ADDENDUM NO. 4:

TO: All prospective bidders
RE: Town of Canton - Armory Community Center Renovation
71 Penland Street, Canton, NC 28716
CGD|PBK Project No. 23029

**RE-BID
TOWN OF CANTON
ARMORY COMMUNITY CENTER
RENOVATION**

Re-Bid Addendum 4 – February 13, 2026

MAIN LEVEL NEW FLOOR PLAN

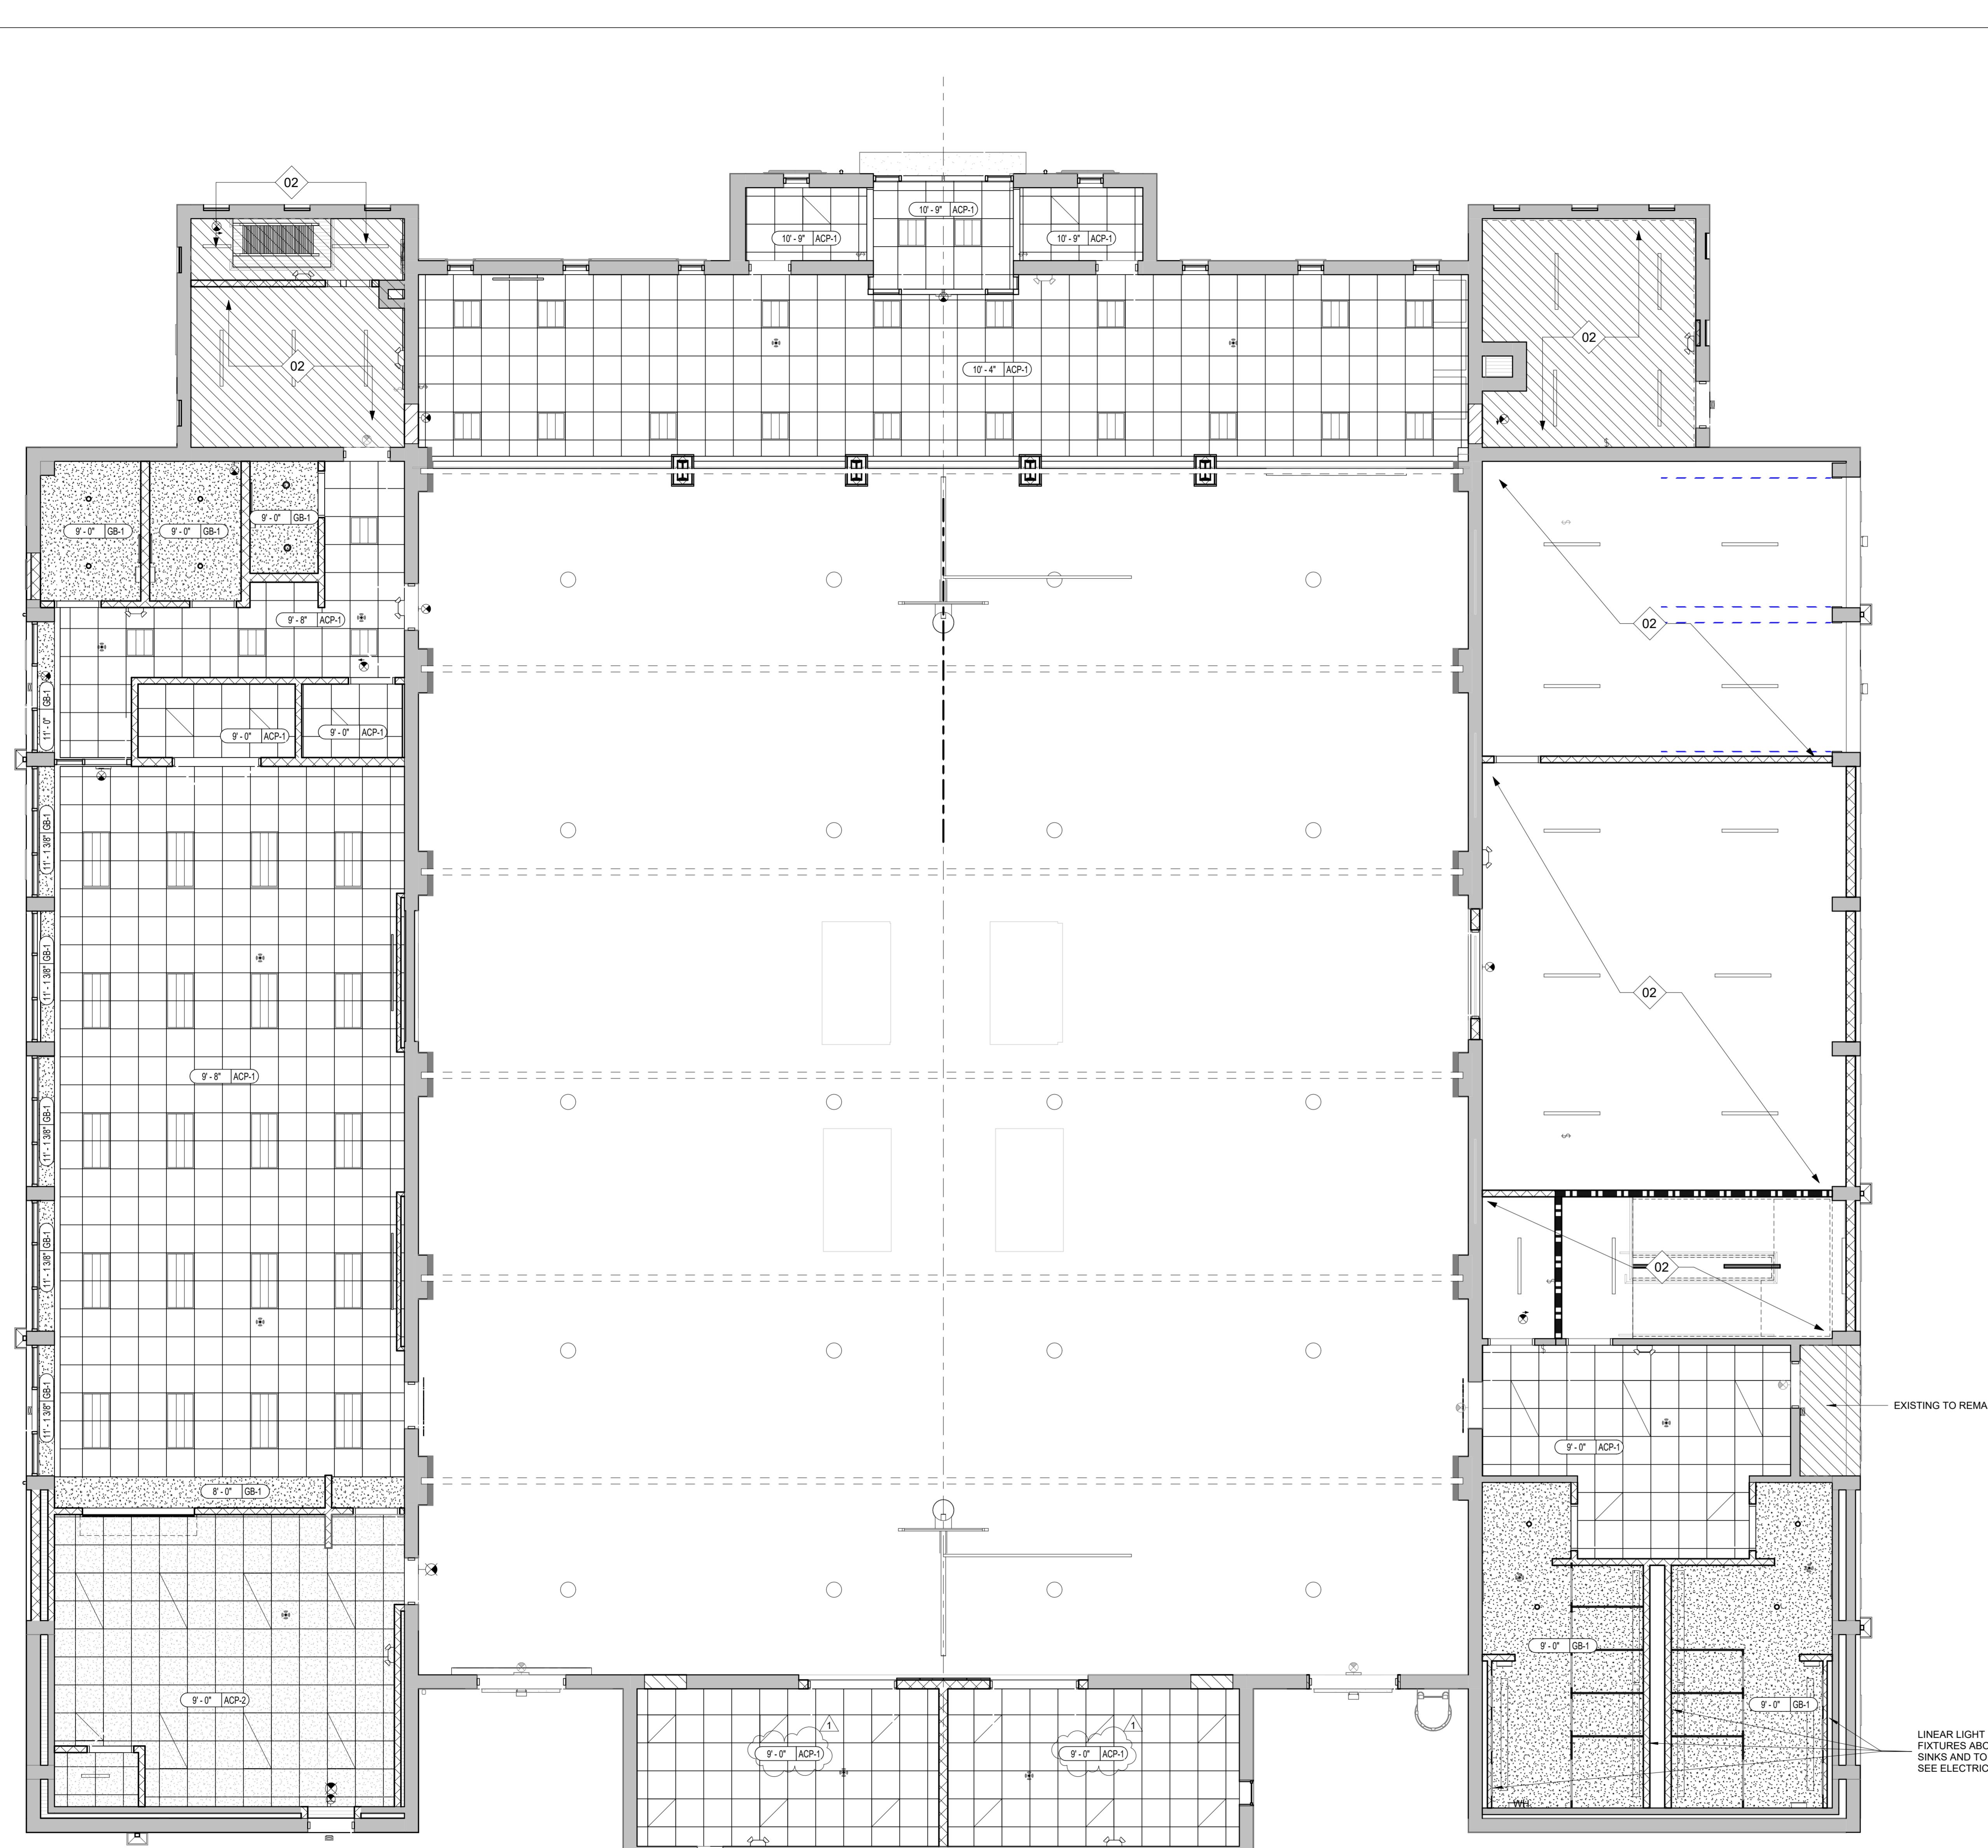
REVISE: Keynote Legend. Keynote #13 is no longer used. All occurrences of Keynote #13 on the floor plan have been removed.

ISSUE: CONSTRUCTION DOCUMENTS
DATE: 1/14/2026
PROJECT NO: 23029
DRAWN BY: JH
CHECKED BY: JDH
MAIN LEVEL REFLECTED
CEILING PLAN

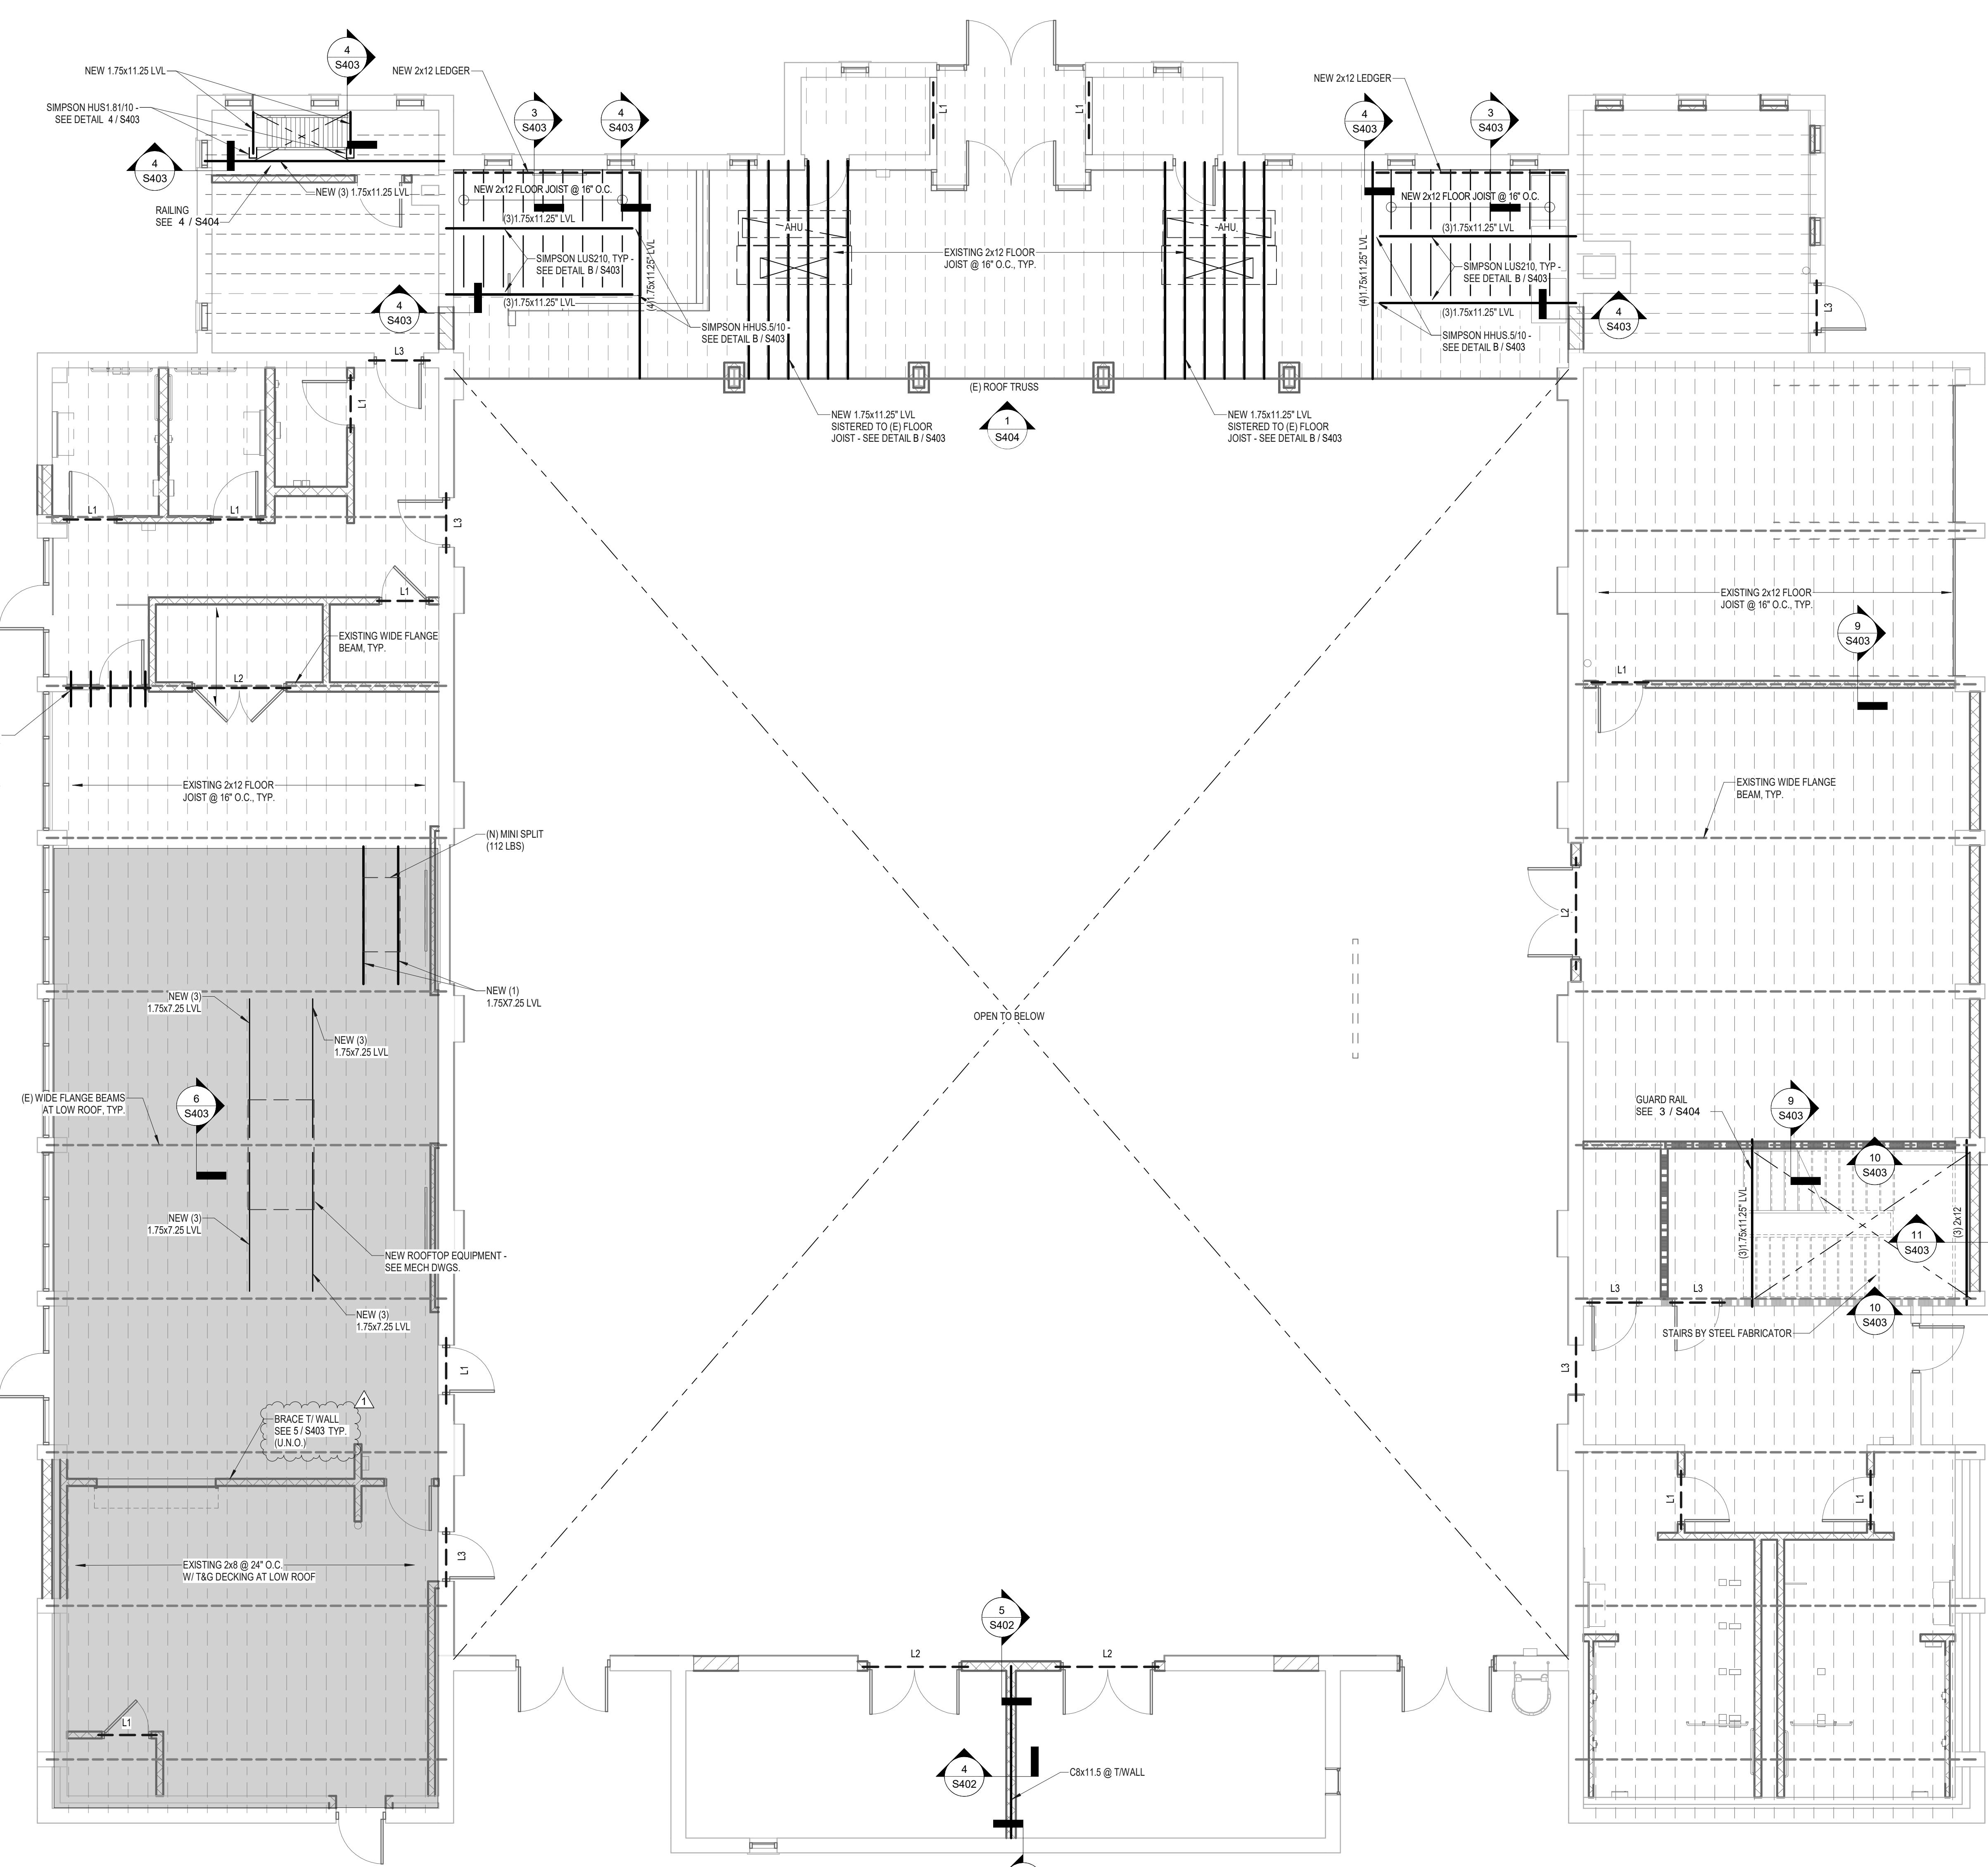
REVISE: Keynote Legend. Keynote #1 is no longer used. Keynote #4 was revised to coordinate with the roof plan. Revise reflected ceiling plan to indicate acoustic ceiling ACP-1 in Team Room 119 and Team Room 120. Revise RCP Legend, item ACP-1.
